Addendum No. 2

Project No.: 21047.1
Date: December 3, 2021
Tender No.: RFT-2021-28
Project: **WATERLOO CATHOLIC DISTRICT SCHOOL BOARD
St. Louis Main Campus, 80 Young Street, Kitchener, ON
Phase 2 - Interior Renovations**

To:	Barry Bryan Associates Architects, Engineers, Project Managers 201- 250 Water Street Whitby, Ontario L1N 0G5 PH: (905) 666-5252 FX: (905) 666-5256 Attention: Kendra Mercieca	Project:	St. Louis Main Campus 80 Young Street Kitchener, Ontario
------------	--	-----------------	--

DESIGN BY:	DE CARIA
DRAWN BY:	DE CARIA
CHECKED BY:	DE CARIA
DATE:	
SCALE:	
FILE:	
PROJECT NO:	4617
DRAWING NO:	M-1.3

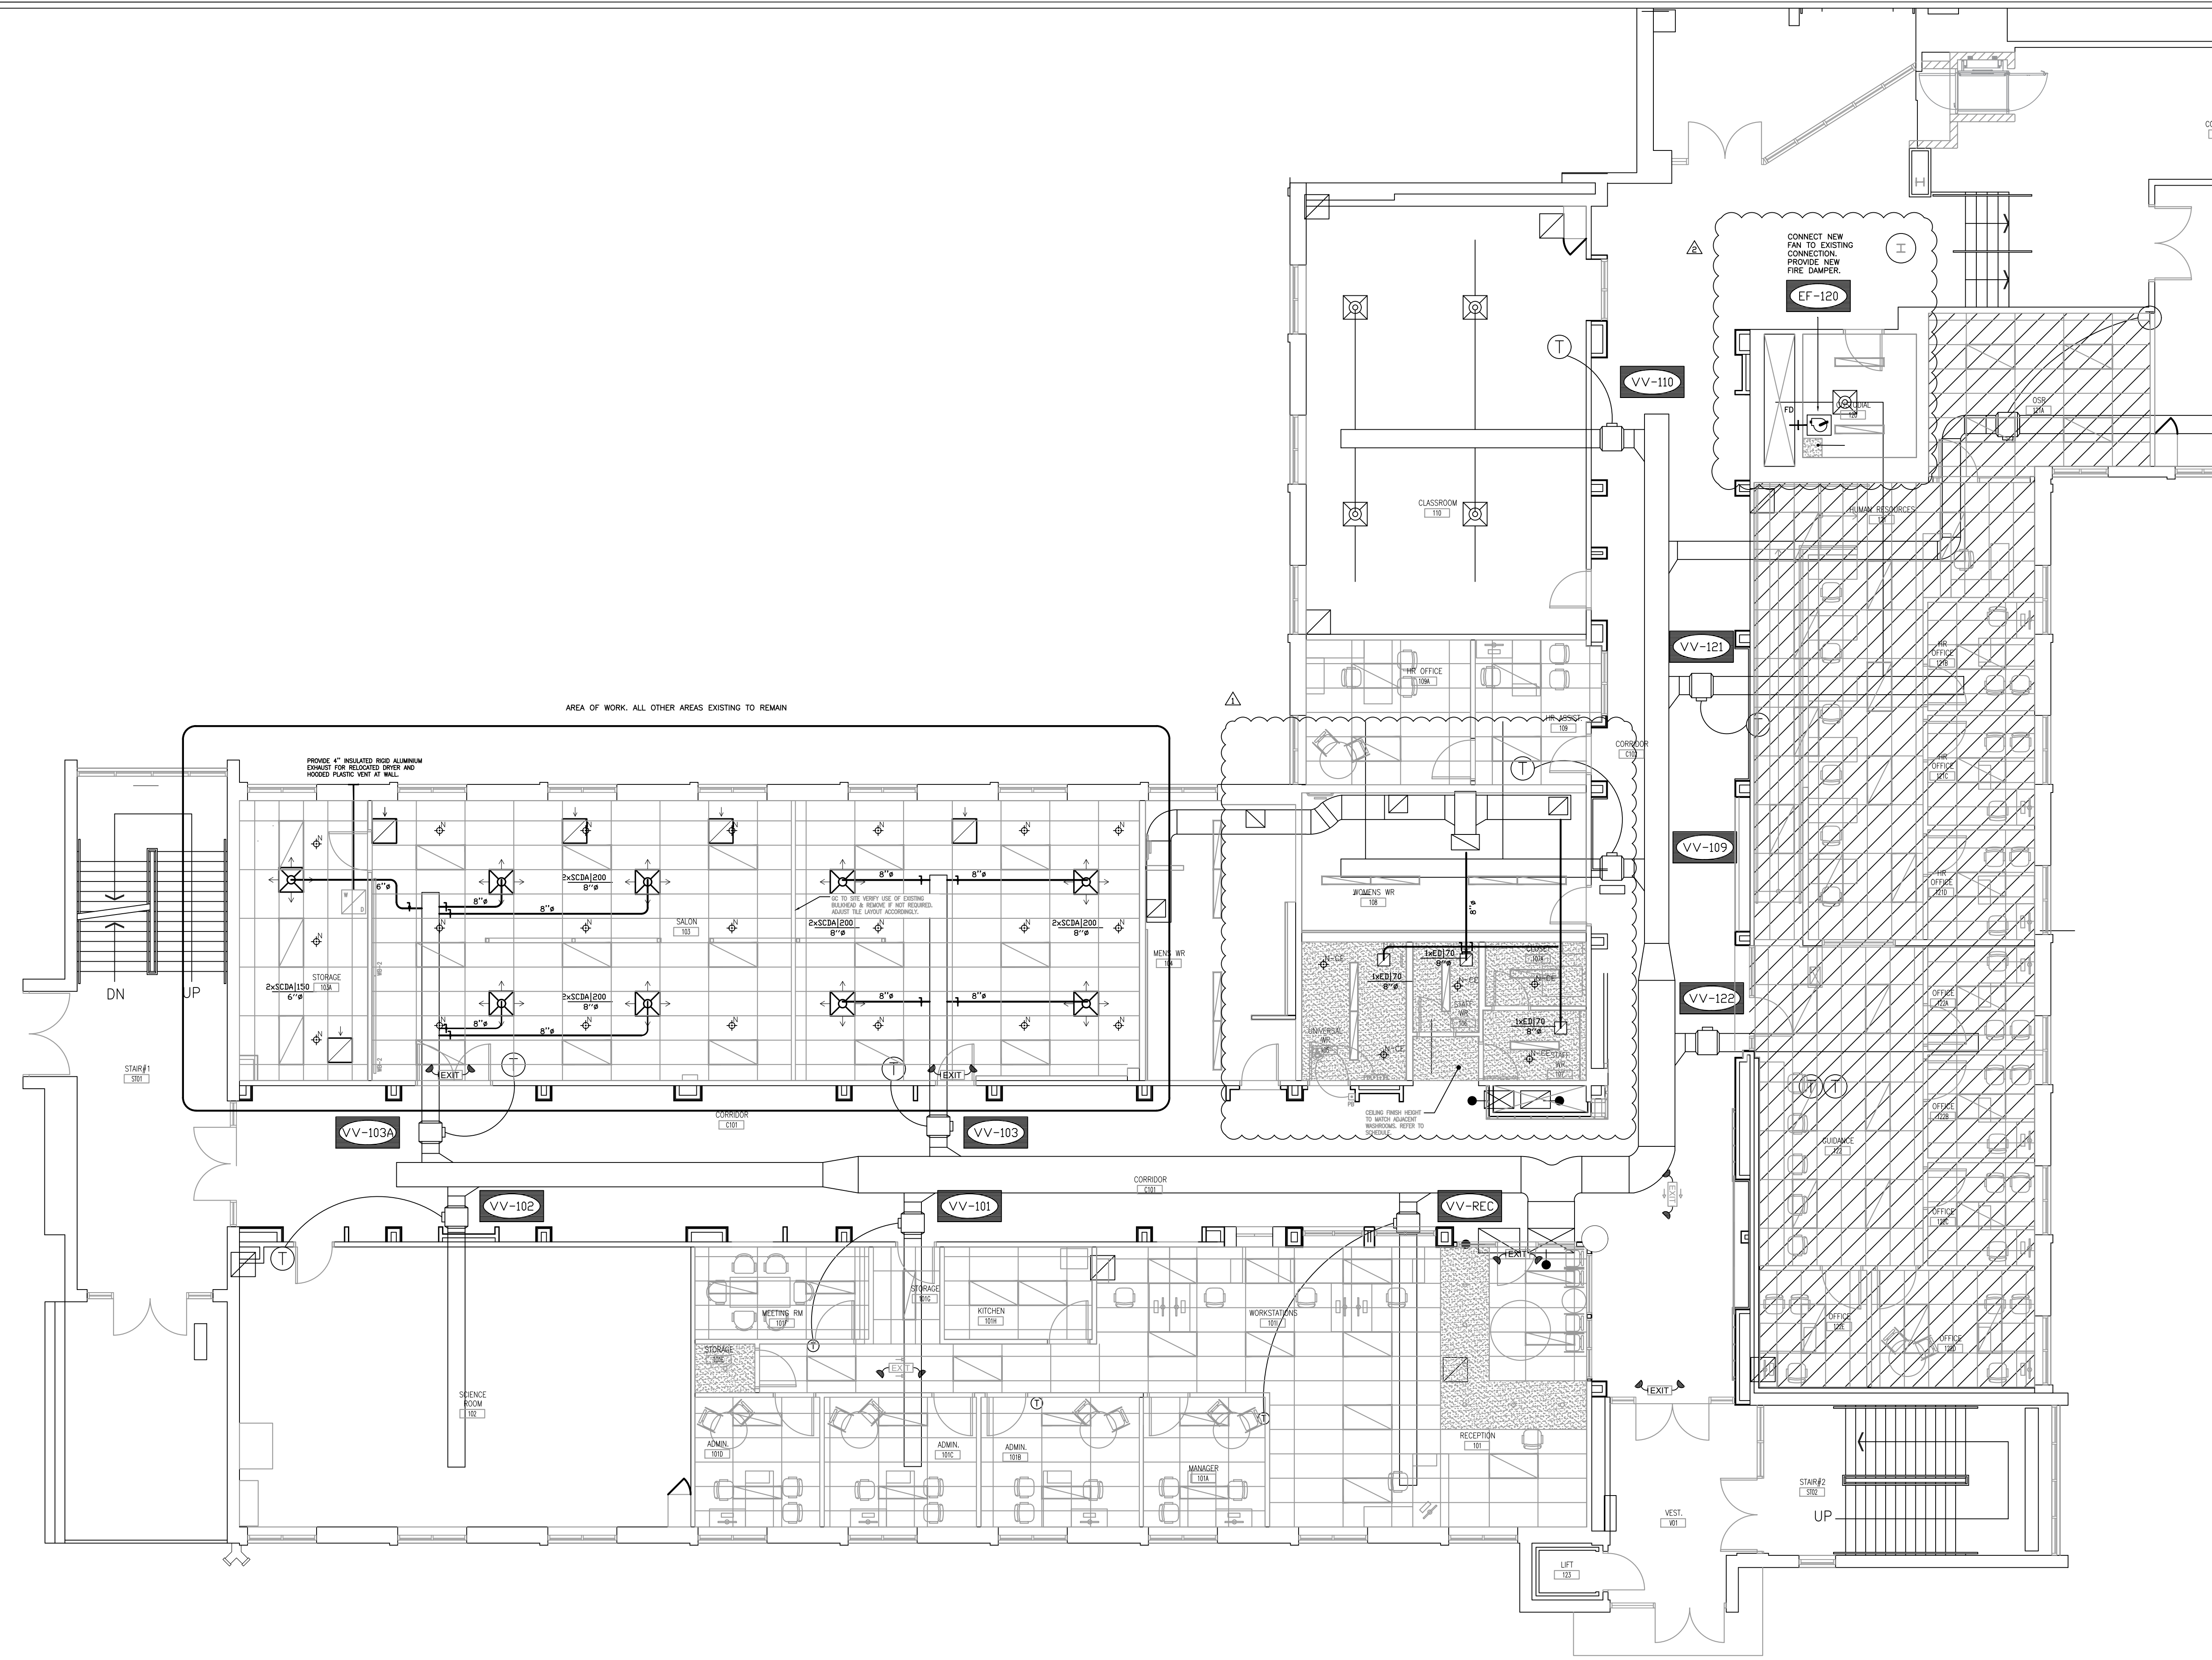
Item 1	References: Drawing ME-0.1 – Mechanical Electrical Schedules - Revision 1 Issued
1.1	Fans TF-101F and TF-101H deleted from project.
Item 2	References: Drawing M-1.3 – First Floor Plan – HVAC and Sprinklers – Revision 1 Issued
2.1	Provide new exhaust fan EF-120. Connect to existing exhaust connection with new fire damper.
